October 12, 2016

**Subject: McDay Septage Facility
Water Availability and Sewer Availability Evaluation**

RH2 Engineering, Inc., (RH2) received a request to review water and sewer availability for the development of the McDay Septage Facility (Facility) for the City of Stanwood (City). The following documents were reviewed:

Figure 1
Existing Water System and Location of Proposed Facility

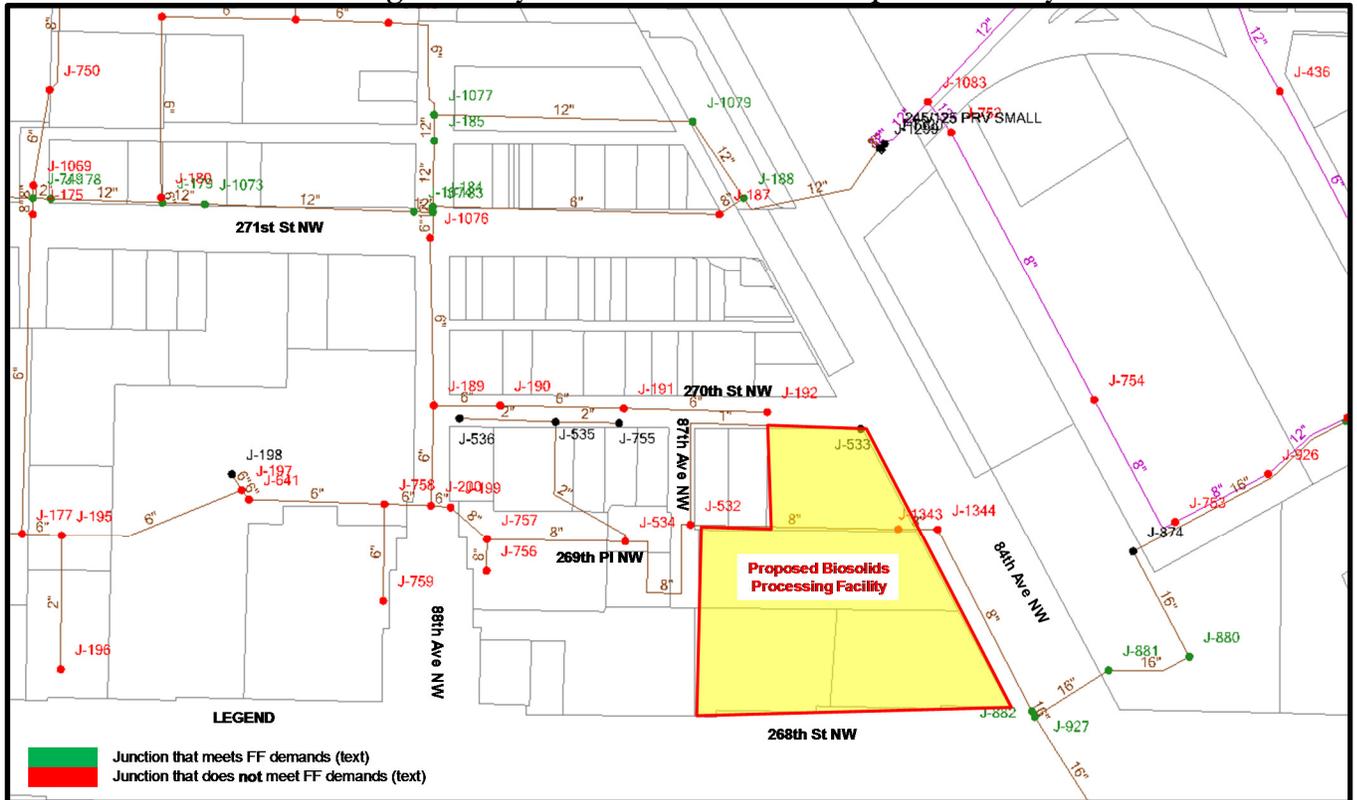
Hydraulic analyses were performed using the City's existing hydraulic model to determine pressure and fire flow availability to the proposed Facility. The model included existing demands for 2013, as calculated for the City's 2015 WSP. The application did not include a conceptual plan for the proposed water system. The City's existing hydraulic model was updated with demands for the proposed Facility. According to the City's WSP, new water mains that will carry fire flow in commercial and industrial areas shall be a minimum of 12 inches in diameter minimum and looped for proposed developments. The fire flow requirement for the proposed Facility was not provided; therefore, the planning-level fire flow requirement for light industrial of 3,500 gallons per minute (gpm) for 3 hours was assumed for the proposed Facility. **Figure 1** shows the location of the proposed Facility.

Fire flow analyses were performed during MDD conditions with the City’s facilities operating at their normal settings. The first set of analyses assumed no off-site water main improvements for the proposed Facility.

The analyses indicate that approximately 700 to 5,600 gpm will be available from nearby fire hydrants, as shown in **Table 4**. The calculated fire flow rates are based on a residual pressure of 20 pounds per square inch (psi) in the water main adjacent to the hydrant and water velocities in the distribution system of 8 feet per second or less. The available fire flow for most of the junctions modeled is less than the general fire flow requirement of 3,500 gpm.

The required size of the on-site water main will be determined by the fire flow requirement of the proposed Facility, but will likely be 12-inch. Off-site improvements in 84th Avenue NW, 270th Street NW, 269th Place NW, and 88th Avenue NW may also be necessary depending on the determined fire flow requirement.

Figure 3
Proposed Facility Flow Path in Existing Wastewater Collection System

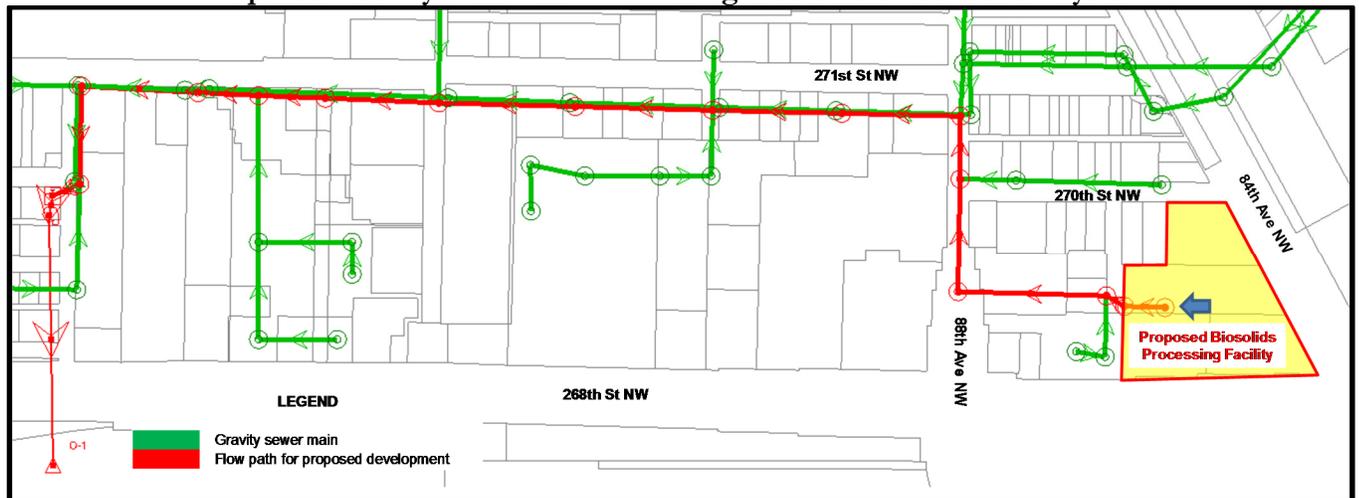
Analyses were performed to determine if the sewer system could handle the projected flow from the proposed Facility. It was assumed the proposed Facility would discharge to MH 19SW-130, and the sewer discharge would follow the flow path shown in **Figure 3**. The analyses are based on 2013 peak hour flow data, which was the base year for the City’s SSP. System monitoring was performed to assist with calibrating the sewer system model based on 2013 flow data and the model’s flows have not been updated since the preparation of the SSP. The results of the analyses indicate that the existing wastewater gravity collection system has sufficient capacity to support the proposed Facility, with 967 LF of 8-inch-diameter sewer main in 88th Avenue NW and 269th Place NW, and 245 LF of 20-inch-diameter sewer main in 94th Drive NW exceeding 50 percent of the pipe’s capacity (**Figure 4**).

Figure 4
Existing Wastewater Collection System Capacity with Proposed Facility

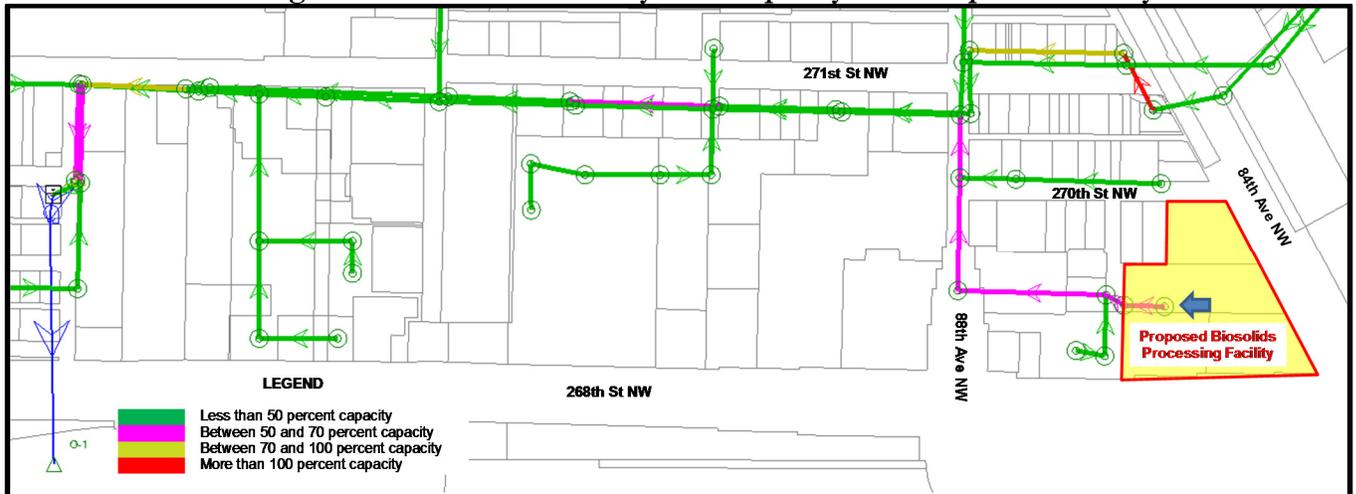
The City’s SSP indicates that if peak flow capacity through a pipe exceeds 70 percent of the pipeline capacity, then plans for an expansion and/or upgrade of the deficient pipe segments should be implemented. Although no pipe segments have projected flow in excess of 70 percent as a result of the proposed Facility, the southernmost 284 LF of 8-inch-diameter sewer main in 88th Avenue NW will be flowing at 66 percent of its capacity during peak hourly flow conditions. There were no CIPs identified in the City’s SSP for this portion of the sewer system. If no permit applications are submitted within the sewer drainage basin area served by this sewer main prior to a permit application being submitted for the proposed Facility, no wastewater gravity collection system improvements will be required to support the proposed Facility.
